TECHNICAL NOTE

Project: **East Witney - Cogges Link Road**
Subject: Flood Risk & Drainage Review
Prepared by Zeean Brydon (Associate Director)
Approved by Iain McNeill (Associate Director)

Job No: **WE01386-TN02**
Page 1 of 10
Rev D
11-04-2011

Figure 23 100 Year plus 20% Design Flood Extent

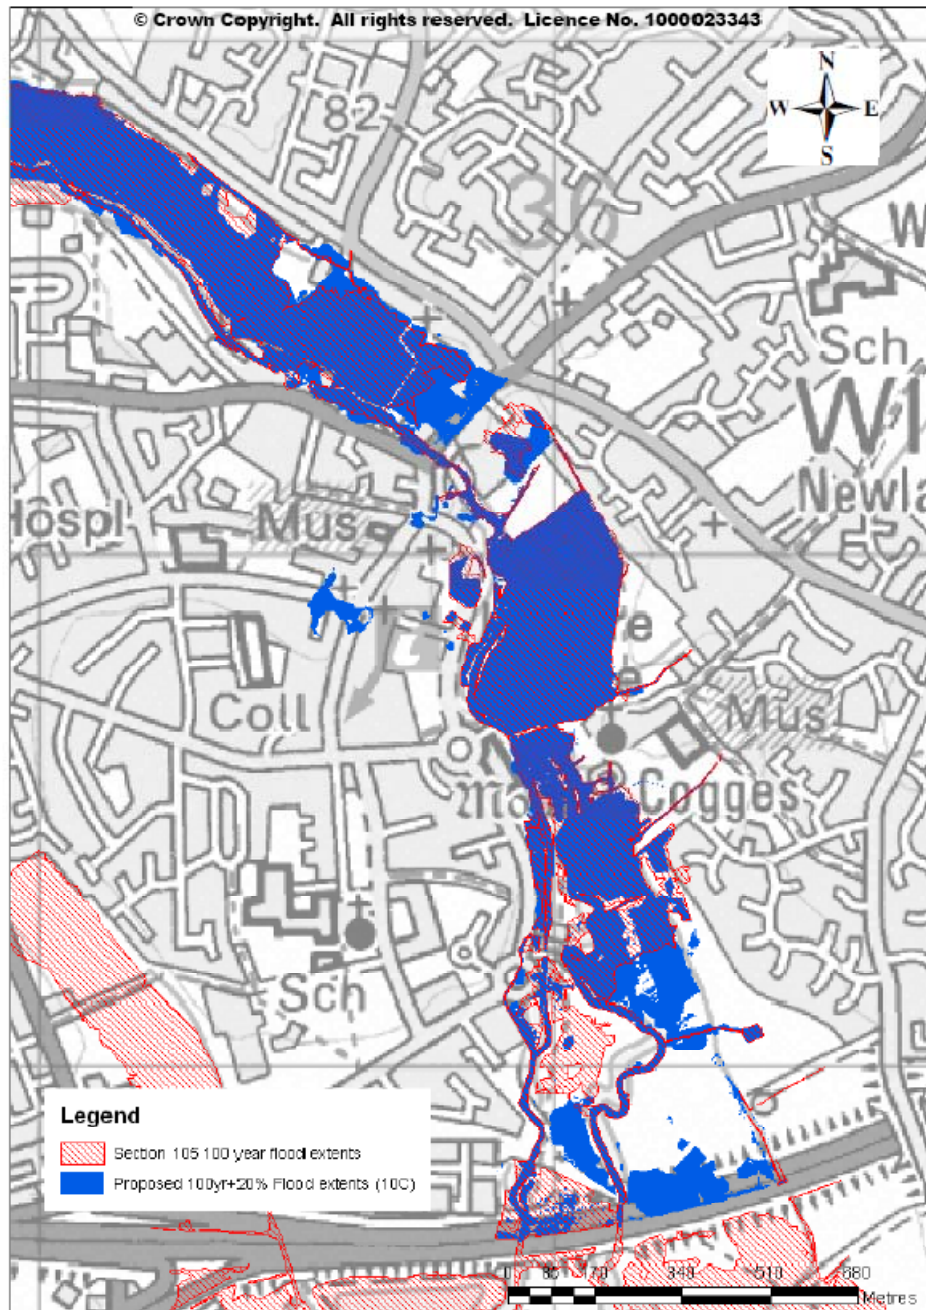
Figure 23 and Section 5.7 of the report compares the proposed 100 year flood extent with the Section 105 flood extent. The report clarifies that this comparison shows "a number of areas where the 100year plus 20% flood extent requires refinement. In particularly the area south east of Bridge Street should be shown to be subject to more general flooding, and flooding along the streets on the opposite side of the river should be clarified".

The report goes on to correctly identify that the S105 outline shows "substantial areas of flood risk in the general vicinity of the CLR" which are not replicated by the Jacobs 2011 calibrated flood model. The reports states that the model shows "small flows taking place over the banks of the various channels into the historic floodplain areas and across the proposed CLR alignment", but confirms that the lack of ponding is a result of "sufficient gradient" across the floodplain.

Within Section 5.7 Jacobs acknowledge that their model requires further refinement to match the S105 flood extent within the vicinity of Bridge Street. This statement gives credence to the validity of the S105 model in representing flood flows within the Witney catchment.

Whilst acknowledging within the text that there are substantial differences between the Jacobs flood model and the S105 flood extent within the vicinity of the CLR no satisfactory explanation is given regarding the difference between the models. The report states merely that "small flows occur" and

that the "lack of ponding is a result of sufficient gradient" across the floodplain. Both statements would appear to be presented solely on the basis that the Jacobs Flood Model and the observations on which it was based are correct. As shown above this starting point is incorrect.

Indeed the extent of flooding within the vicinity of the CLR and properties within the Cogges area, as shown on the S105 model, is considered more representative of the actual flooding as experienced and as supported by photographs which were taken at or near peak flood support.

Again there is no satisfactory explanation as to why these areas of flooding have been removed from the calibrated model.
